**Harvey Jones Channel River Outlet
SSCAFCA IFB #: 2021-04**

ADDENDUM #1 (September 17, 2021)

Addendum #1 provides answers to questions that were asked during the pre-bid conference and/or submitted by potential bidders for this project. Addendum #1 also provides an updated Sheets 1 and 9 of the plan set.

HARVEY JONES CHANNEL RIVER OUTFALL

TYPICAL SECTIONS

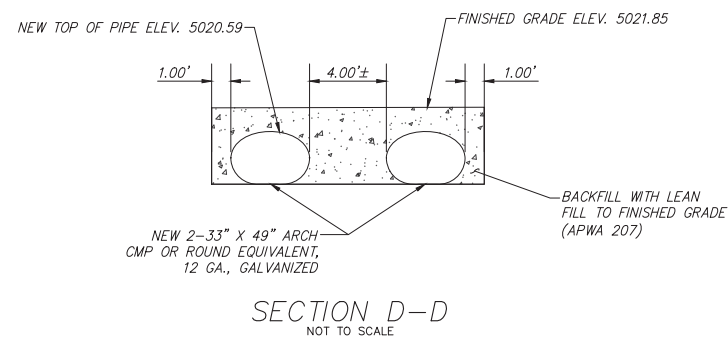
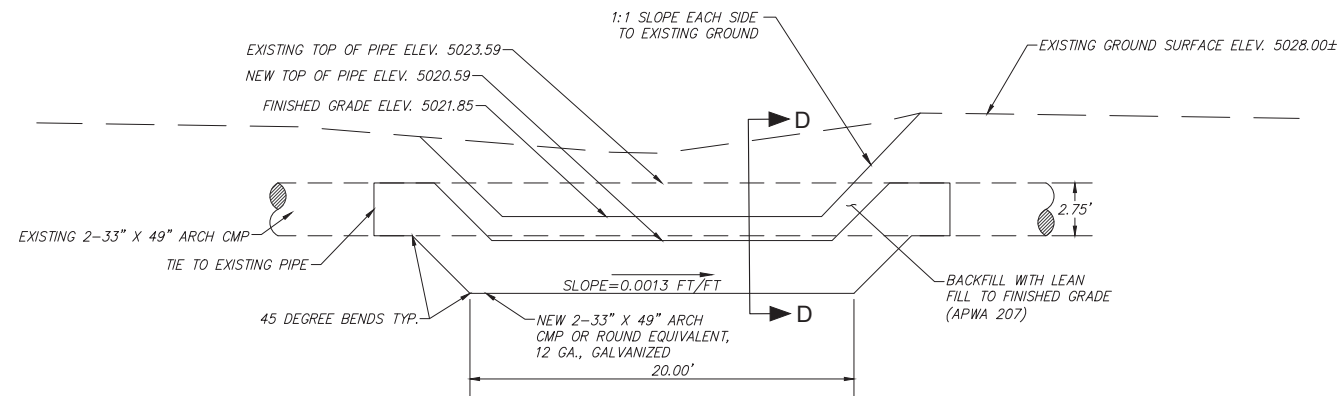
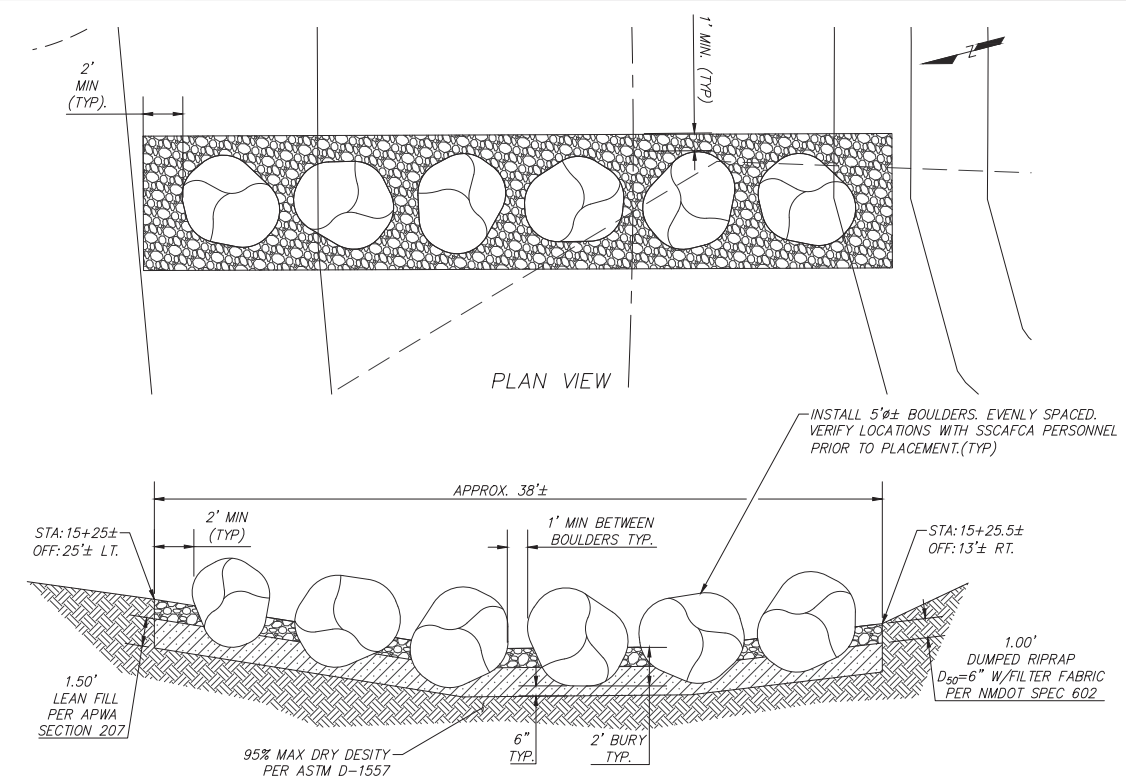
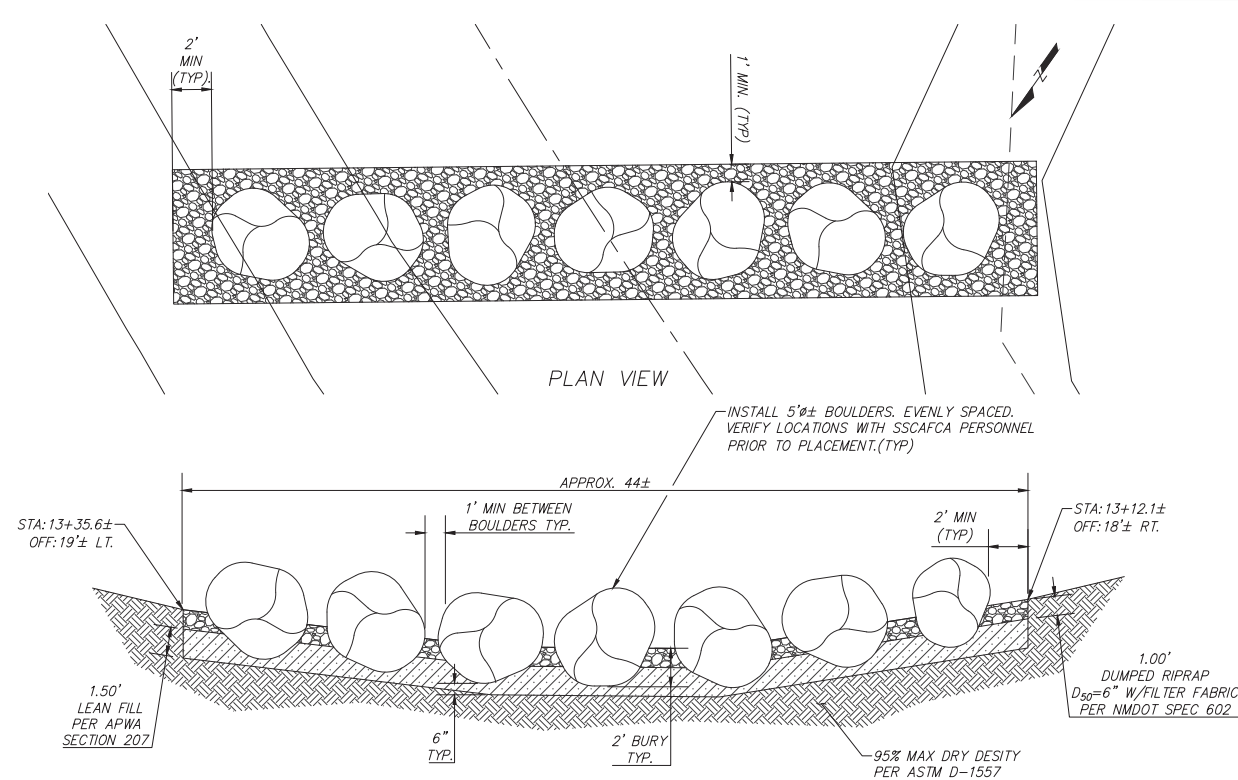
Sheet 9 Typical Sections – (Change: modifications to Section C-C and new Section D-D)
